Three Mile Island Nuclear Station Unit 1 (TMI-1)  
Operating License No. DPR-50  
Docket No. 50289

Technical Specification Change Request No. 70

The licensee requests that the attached changed pages replace pages 2-3, 2-6, and 3-34, through 3-36a and Figures 2.1-2, 2.3-2 and 3.5-2A through 3.5-2H. Figures 3.5-2I through 3.5-2M are to be deleted.

Figure 2.1-2

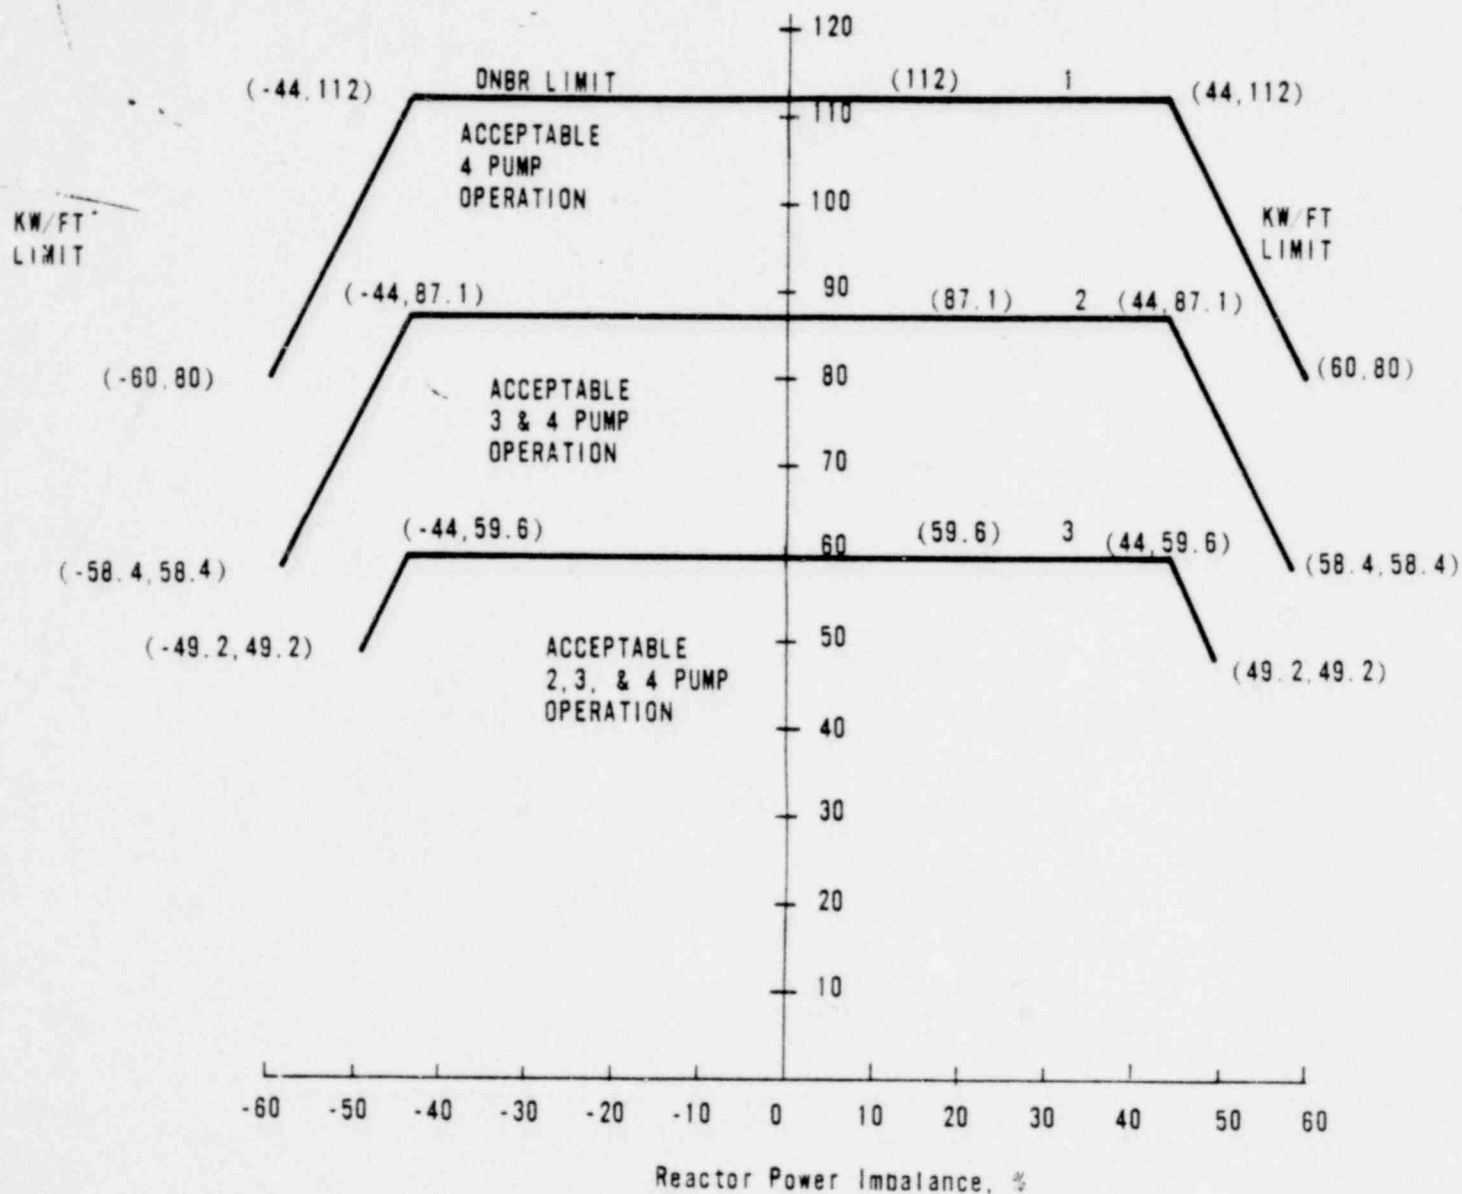
The curve of Figure 2.1-1 is the most restrictive of all possible reactor coolant pump-maximum thermal power combinations show in Figure 2.1-2. The curves of Figure 2.1-3 represent the conditions at which a minimum DNBR of 1.3 is predicted at the maximum possible thermal power for the number of reactor coolant pumps in operation or the local quality at the point of minimum DNBR is equal to 22 percent, (3) whichever condition is more restrictive.

The maximum thermal power for three pump operation is 87.1 percent due to a power level trip produced by the flux-flow ratio (74.7 percent flow x 1.08 = 80.7 percent power) plus the maximum calibration and instrumentation error. The maximum thermal power for other reactor coolant pump conditions is produced in a similar manner.

Figure 2.3-2

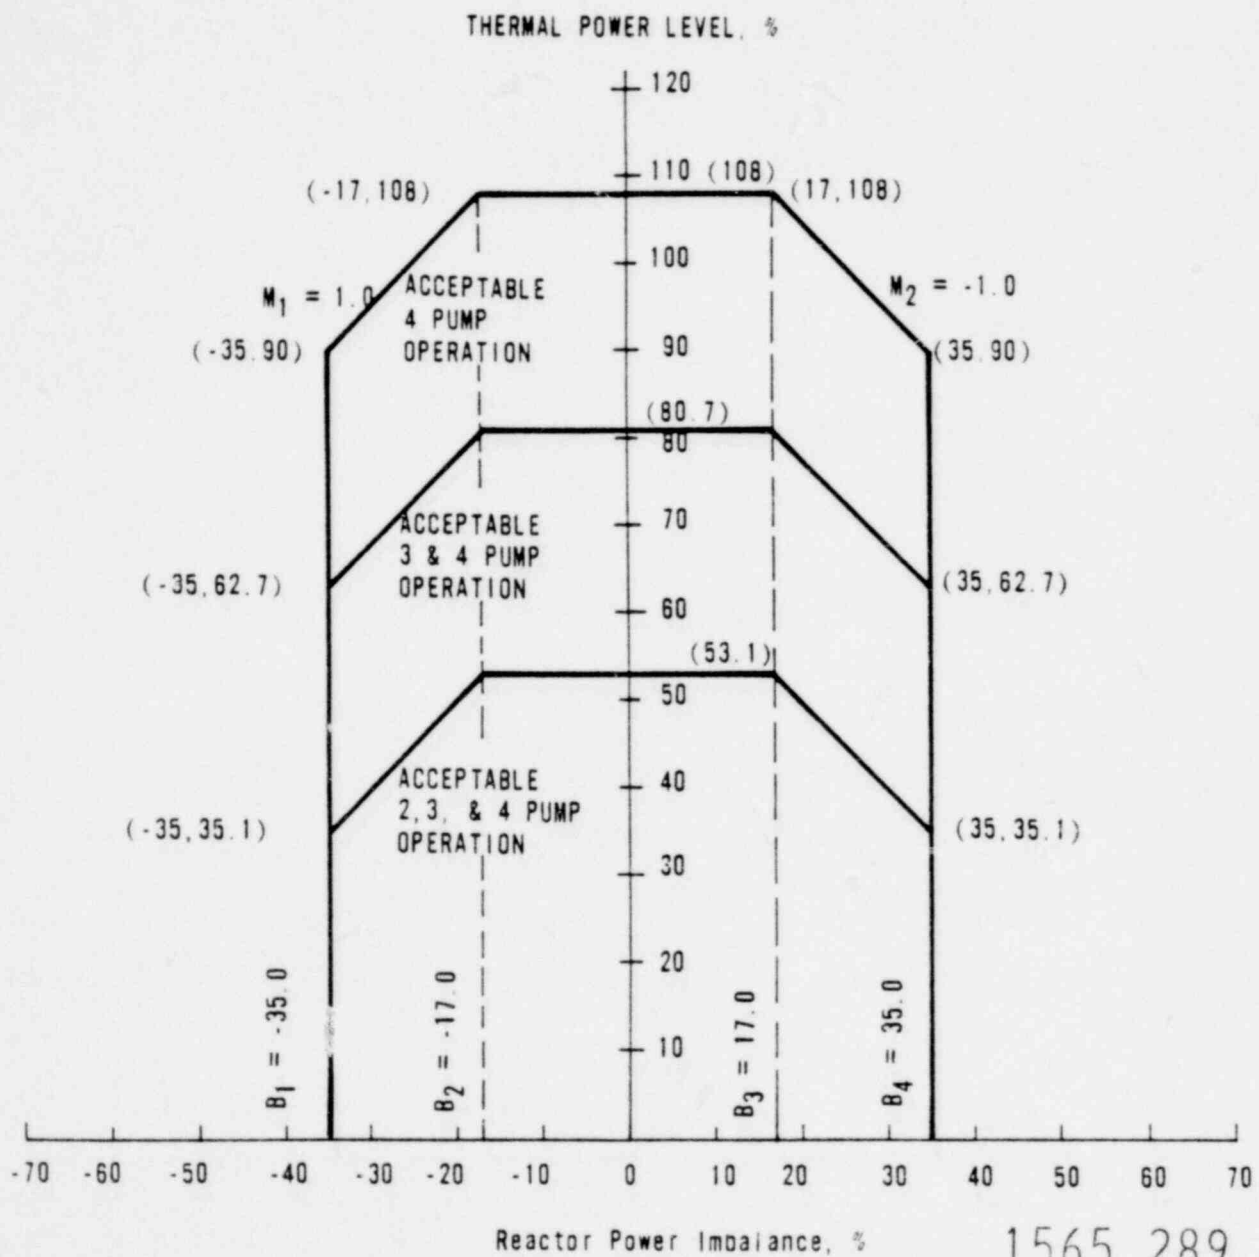
The power-imbalance boundaries are established in order to prevent reactor thermal limits from being exceeded. These thermal limits are either power peaking Kw/ft limits or DNBR limits. The reactor power imbalance (power in the top half of the core minus power in the bottom half of core) reduces the power level trip produced by the power-to-flow ratio so that the boundaries of Figure 2.3-2 are produced. The power-to-flow ratio reduces the power level trip and associated reactor power/reactor power-imbalance boundaries by 1.08 percent for a one percent flow reduction.

Figure 3.5-2A

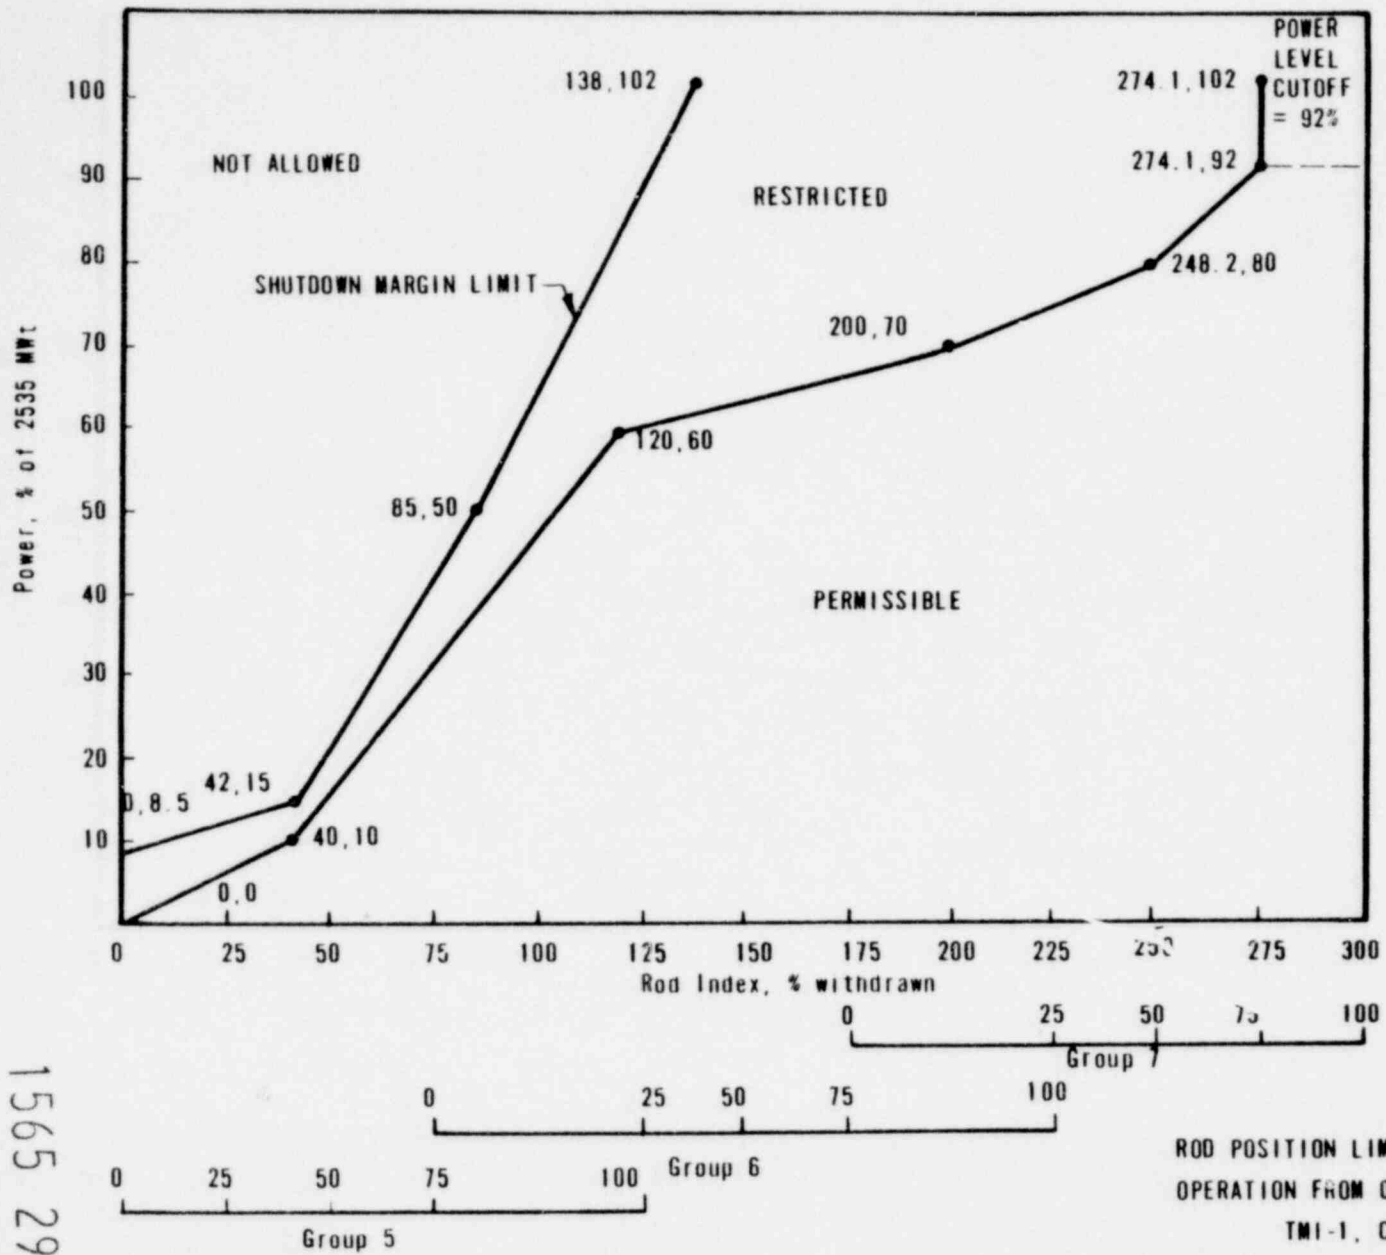
- d. Except for physics tests if quadrant tilt exceeds the tilt limit power shall be reduced immediately to below the power level cutoff (see Figures 3.5-2A, and 3.5-2B. Moreover, the power level cutoff value shall be reduced 2 percent for each 1 percent tilt in excess of the tilt limit. For less than four pump operation, thermal power shall be reduced 2 percent of the thermal power allowable for the reactor coolant pump combination for each 1 percent tilt in excess of the tilt limit.

2. The control rod group withdrawal limits (Figures 3.5-2A, 3.5-2B, 3.5-2C, 3.5-2D, and 3.5-2H, shall be reduced 2 percent in power for each 1 percent tilt in excess of the tilt limit.

Figure 3.5-2E

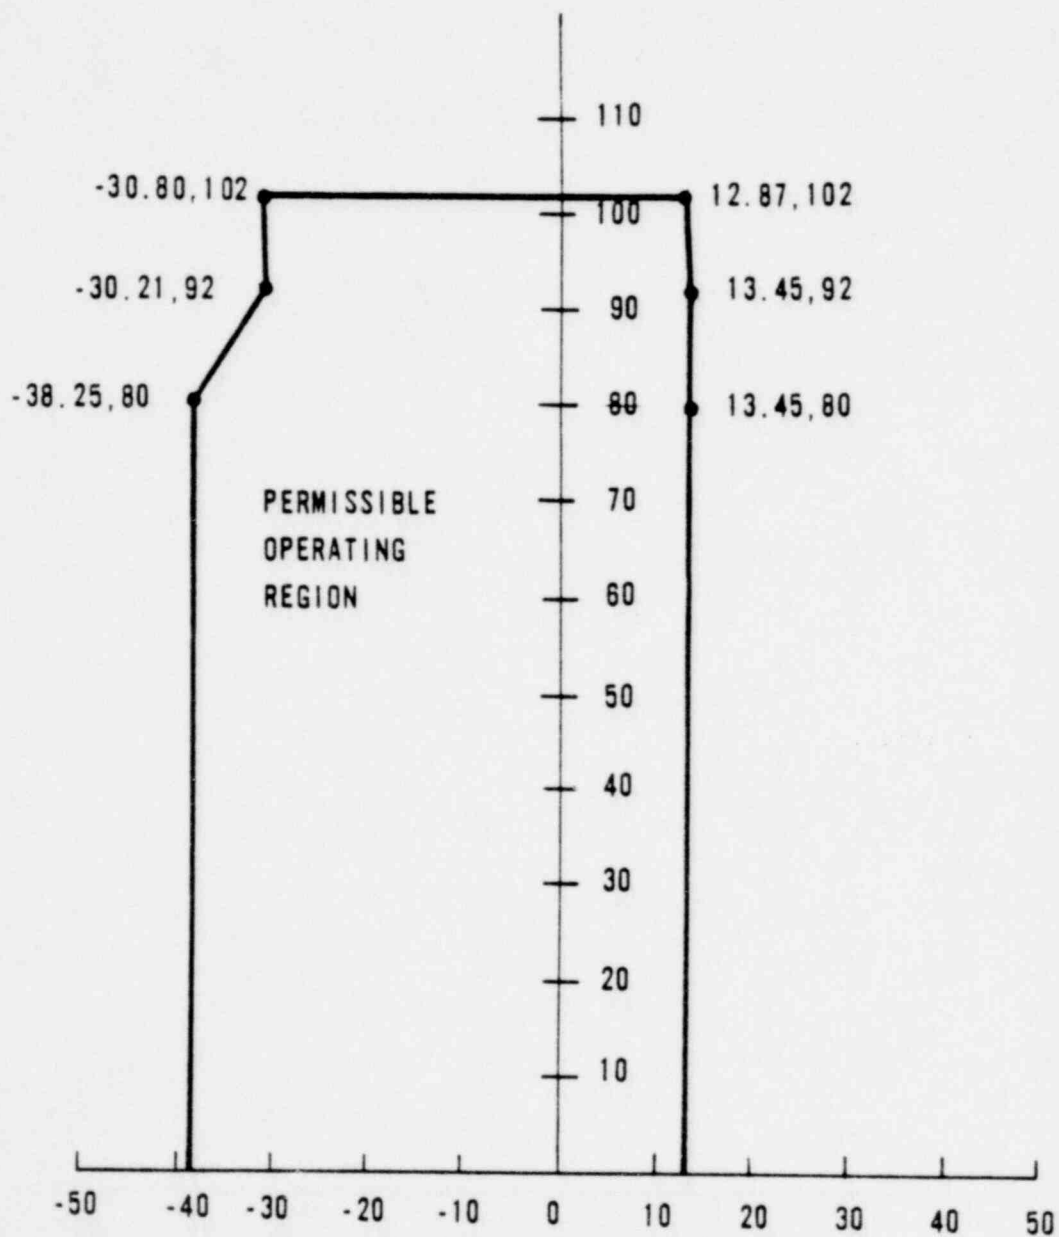
3. The operational imbalance limits (Figure 3.5-2E, and 3.5-2F) shall be reduced 2 percent in power for each 1 percent tilt in excess of the tilt limit.

The power-imbalance envelope defined in Figures 3.5-2E, and 3.5-2F is based on LOCA analyses which have defined the maximum linear heat rate (see Figure 3.5-2G such that the maximum clad temperature will not exceed the Final Acceptance Criteria (2200F). Operation outside of the power imbalance envelope alone does not constitute a situation that would cause the Final Acceptance Criteria to be exceeded should a LOCA occur. The power imbalance envelope represents the boundary of operation limited by the Final Acceptance Criteria only if the control rods are at the withdrawal/insertion limits as defined by Figures 3.5-2A, 3.5-2B, 3.5-2C, 3.5-2D, 3.5-2H, and if quadrant tilt is at the limit. Additional conservatism is introduced by application of:

Figure 3.5-2G

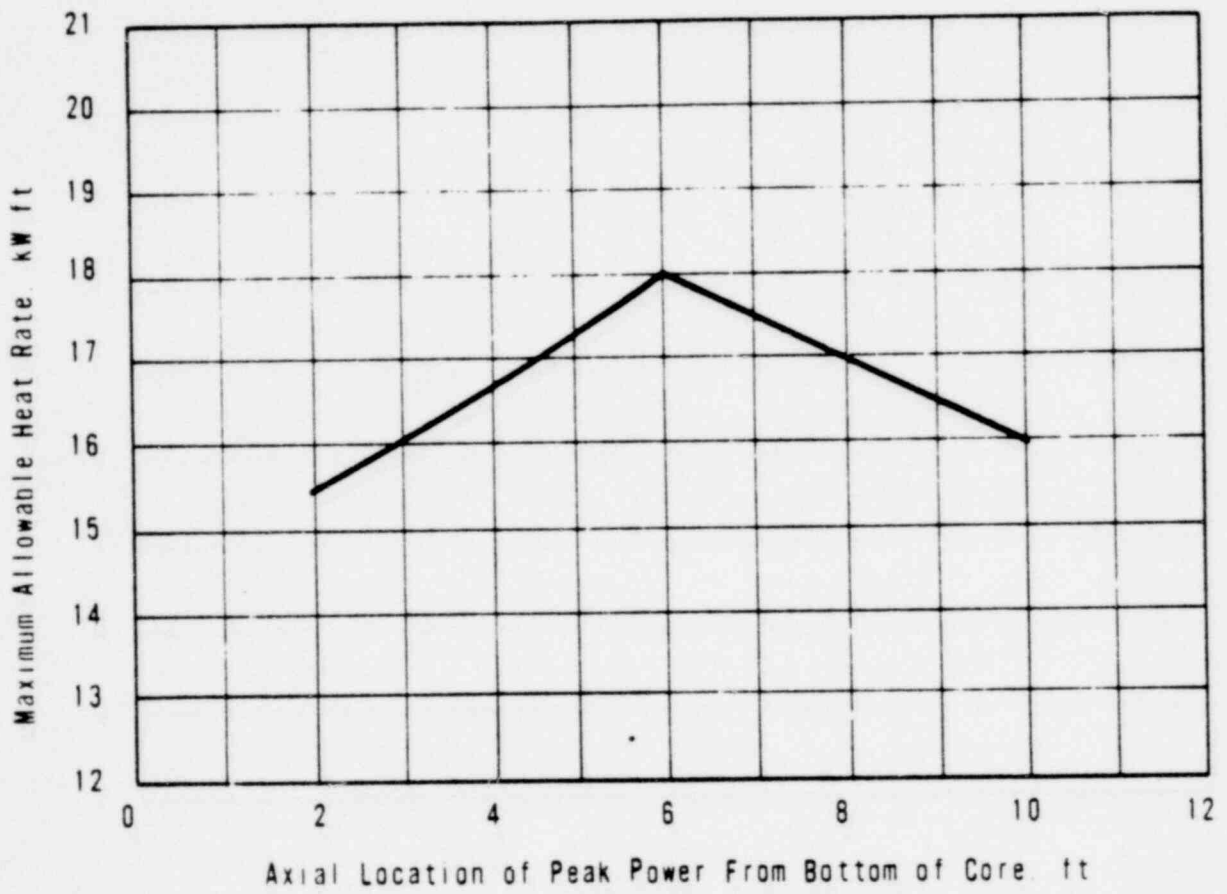
- 3.5.2.7 A power map shall be taken at intervals not to exceed 30 effective full power days using the incore instrumentation detection system to verify the power distribution is within the limits shown in Figure 3.5-2G.
